## Jetstream® CPX-1000 Release Notes

Release 3.2

Document Number 1000-A2-GK41-00  
October 2002

## New CPX-1000 PDU

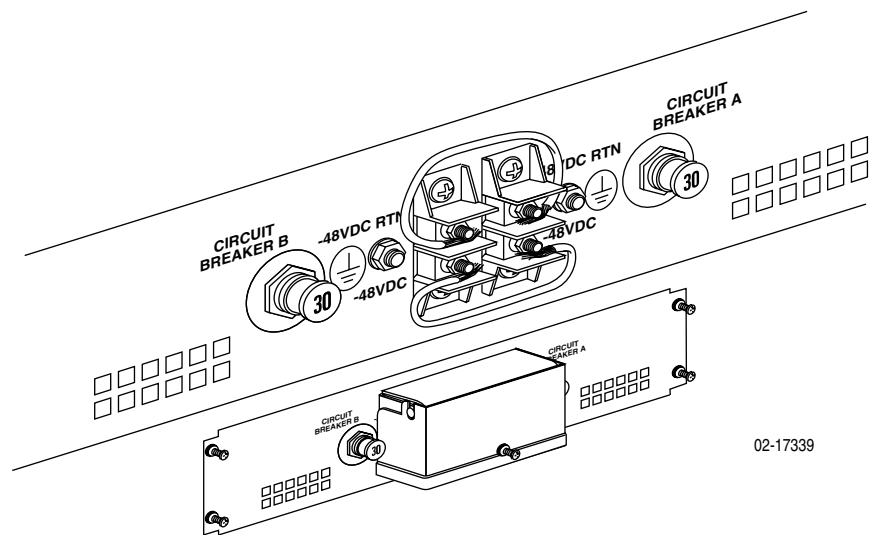
Some models of the CPX-1000 are shipping with a different type of PDU than the one shown in the user documentation.

The new PDU contains two plunger-type circuit breakers instead of one double-pole switch. To remove power from the PDU, pull each circuit breaker plunger out. To apply power to the PDU, push each circuit breaker plunger completely in and release.
